I object to the development project SSD 9679 “Hills of Gold Wind Farm” consisting of 70 wind turbines in the Nundle and Hanging Rock district of Northern New South Wales.

I propose a number of questions and tasks for the proponent that require a response:

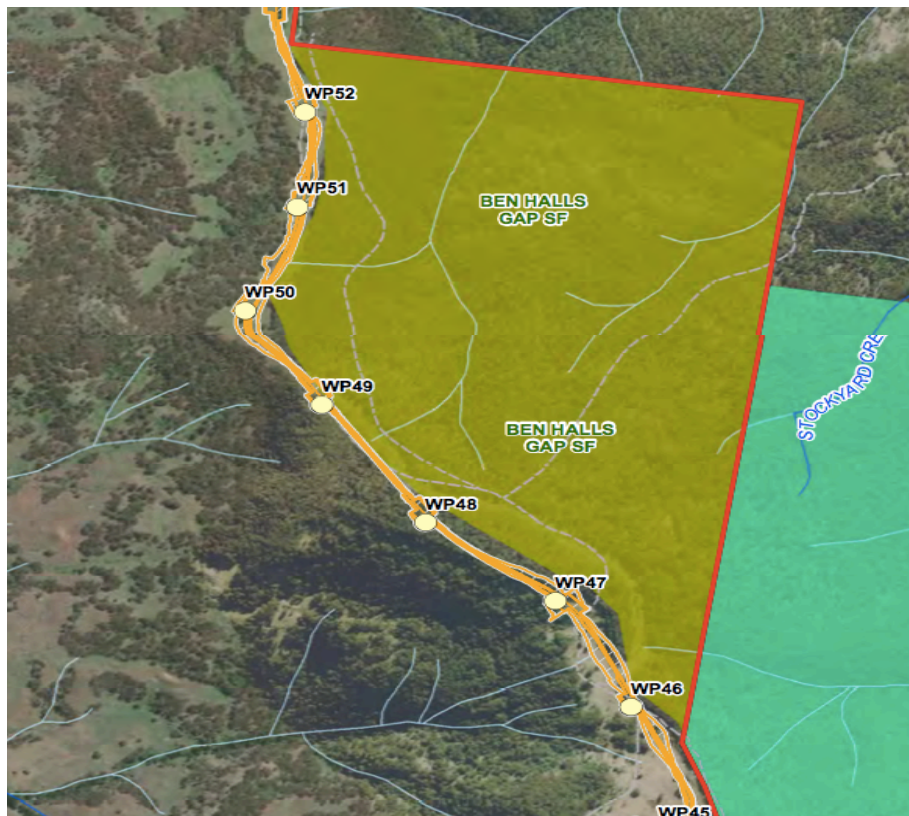
“The Project Area also includes one Crown land allotment under perpetual lease, forming Ben Halls Gap State Forest. Consultation has occurred with NSW Forestry Corporation who is responsible for managing the Ben Halls Gap State Forest currently under a perpetual lease. An agreement is in place with the leaseholder and advice from Forestry Corporation of NSW (Forestry Corporation) has been received that this lease is allowed. The lease will require final sign-off from Forestry Corporation upon final design for registration of the lease.” ***The agreement is not with the landholder only the leaseholder therefore not valid, landholder 12 should not be included in the hosting project infrastructure.***

As no agreement exists with landholder 12, turbine placements on the boundary are not within acceptable distances from non-host property boundary (i.e. 460 meters).

“Turbines shall not be located within a distance two times the height of the turbine (including the tip of the blade) from a non-related property boundary” quoted from the guidelines of the Upper Lachlan Development Control Plan 2010 for Wind Farms and the Upper Hunter Development control Plan 2015 for Wind Farms. Additionally Turbine placement 10-60 meter proximity to a State Forest is not acceptable for biodiversity and bushfire issues.

Turbine placement of WP 46,47,48,49,50,51,52 need to be extended to 460 meters from the Ben Hall’s State Forest boundary therefore locating turbines on a >30% gradient and non compliant with turbine development guidelines.

A total of 7 turbines require immediate removal from the project design.

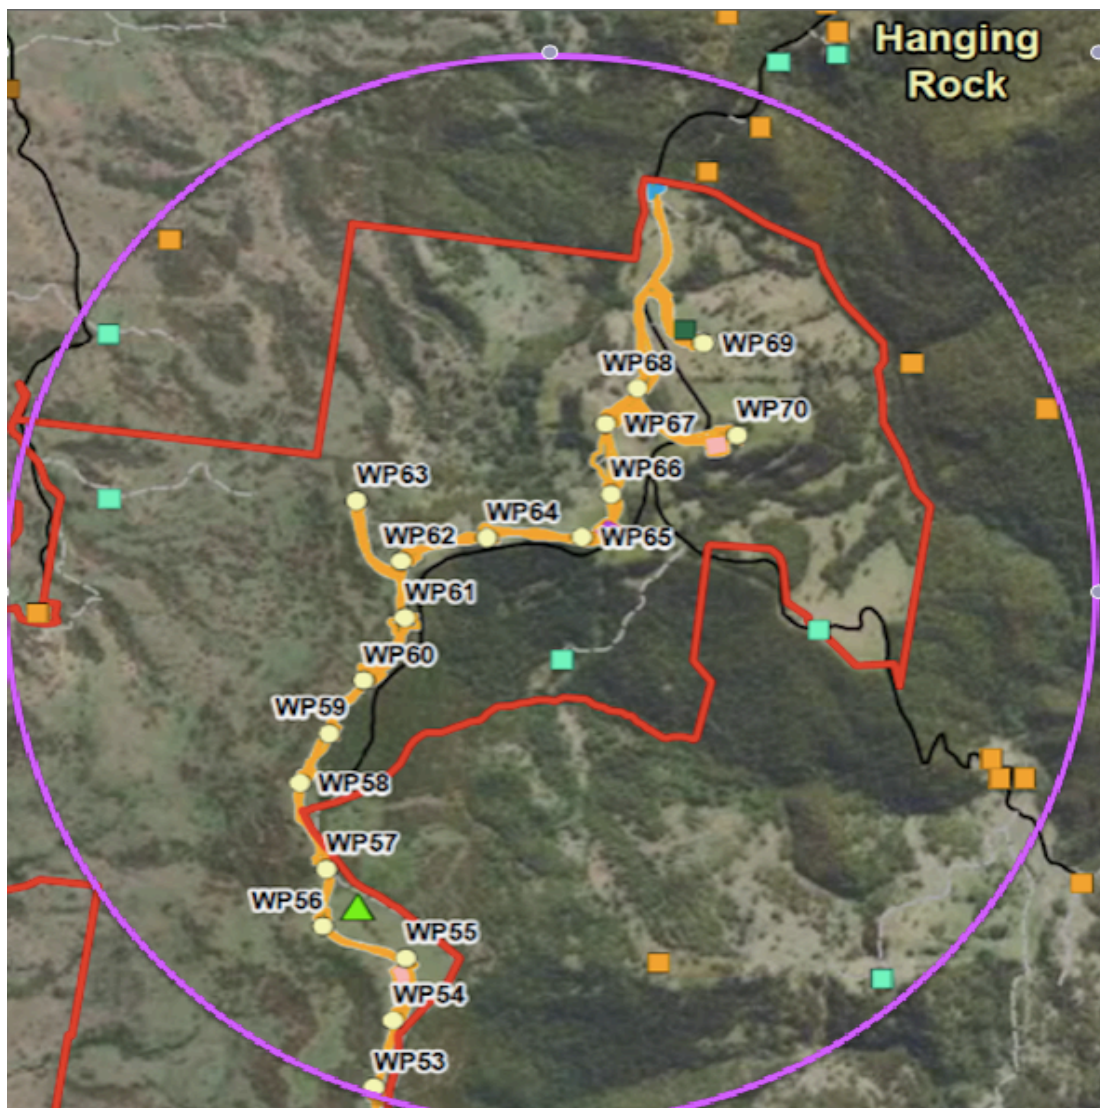
Positioned on the Northern end of the Hanging Rock turbine placement design, the immediate turbine removal is required based upon distance to 21 non-associated residences. All 21 non-associated residences are lifestyle properties with little consultation and **10 dwellings having desktop analysis** for visual assessment.

Turbine numbers WP 61,62,63,64,65,66,67,68,69,70 are all situated under the required distance of 3100 meters from multiple non-associated dwellings that have no benefit sharing agreements with the project.

Turbine numbers WP 53,54,55,56,57,58,59,60 are all situated within 1 km of the presently under construction non-associated residence located near WP57 in the map below. **This non-associated dwelling located near WP57 is not even registered on the map for assessment.**

A total of 18 turbines require immediate removal from the project design.

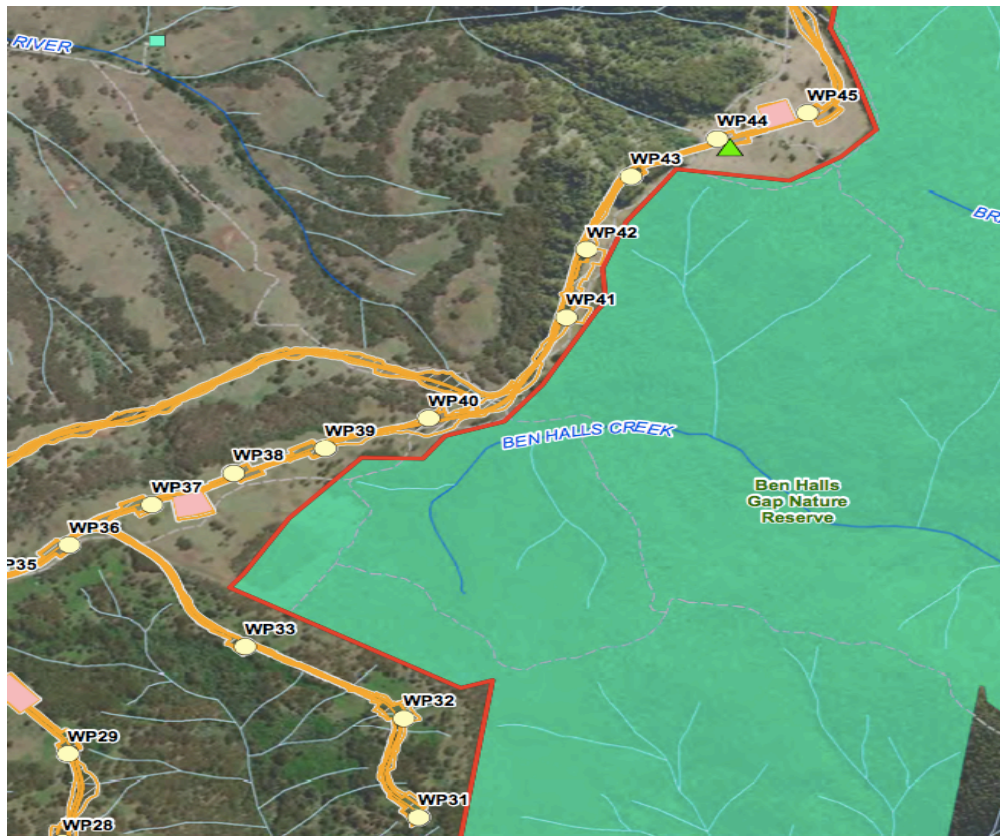
Ben Halls Gap Nature Reserve is a IUCN Category 1a - Strict nature reserve. A strict nature reserve is an area set aside to protect biodiversity and geological/geomorphological features, where human visitation, use and impacts are strictly controlled and limited to ensure protection of the conservation values. Such protected areas can serve as indispensable reference areas for scientific research and monitoring.

The EIS does not reference significant species in, or the protection required for, Ben Halls Gap Nature Reserve. The EIS states, “an appropriate buffer must be maintained with the National Park Estate where practicable” (page 278 Appendix D Biodiversity Development Assessment Report). Ecologist Phil Spark suggests remnant open forest with a high abundance of threatened species should be buffered by at least a 500m setback.

Turbine placements on the boundary of Ben Hall’s Gap Nature Reserve are not within acceptable distances from a non-host property boundary (i.e. 460 meters). “Turbines shall not be located within a distance two times the height of the turbine (including the tip of the blade) from a non-related property boundary” quoted from the guidelines of the Upper Lachlan Development Control Plan 2010 for Wind Farms and the Upper Hunter Development control Plan 2015 for Wind Farms. Additionally turbine placement within 100-meter boundary of Ben Hall’s Nature Reserve is not acceptable for biodiversity and bushfire issues.

Turbine placement of WP 31,32,33,38,39,40,41,42,43,44,45 need to be extended to 460 meters from the Ben Hall’s Gap Nature Reserve boundary therefore locating turbines on a > 30% gradient and non compliant with turbine development guidelines.

A total of 11 turbines require immediate removal from the project design.

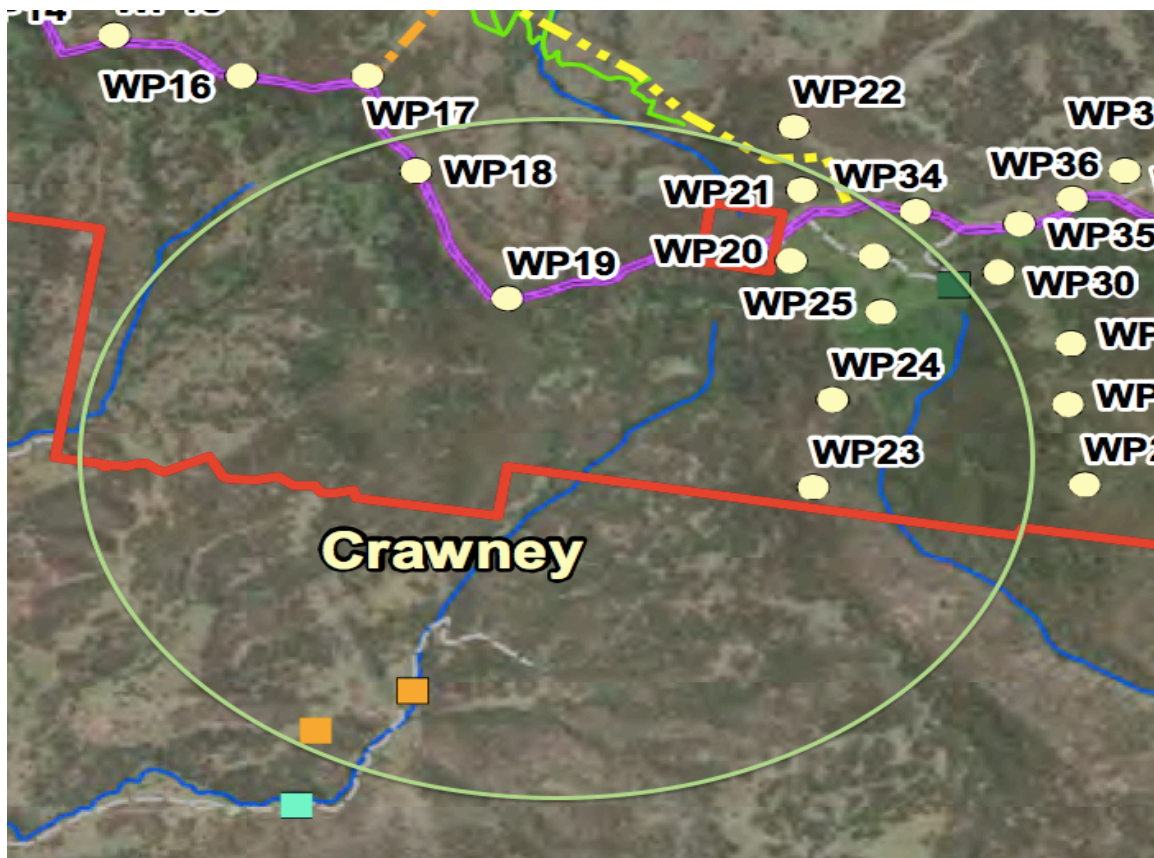
Positioned on the Southern end of the Crawney turbine placement design, the immediate turbine removal is required based upon distance to 2 non-associated residences NAD 01 and NAD 69. The 2 non-associated properties have had little or no consultation with 1 dwelling having desktop analysis for visual assessment.

Turbine numbers WP 18,19,20,23,24,25 are all situated under the required distance of 3100 meters from the non-associated dwellings that have no benefit sharing agreements with the project.

A total of 6 turbines require immediate removal from the project design.
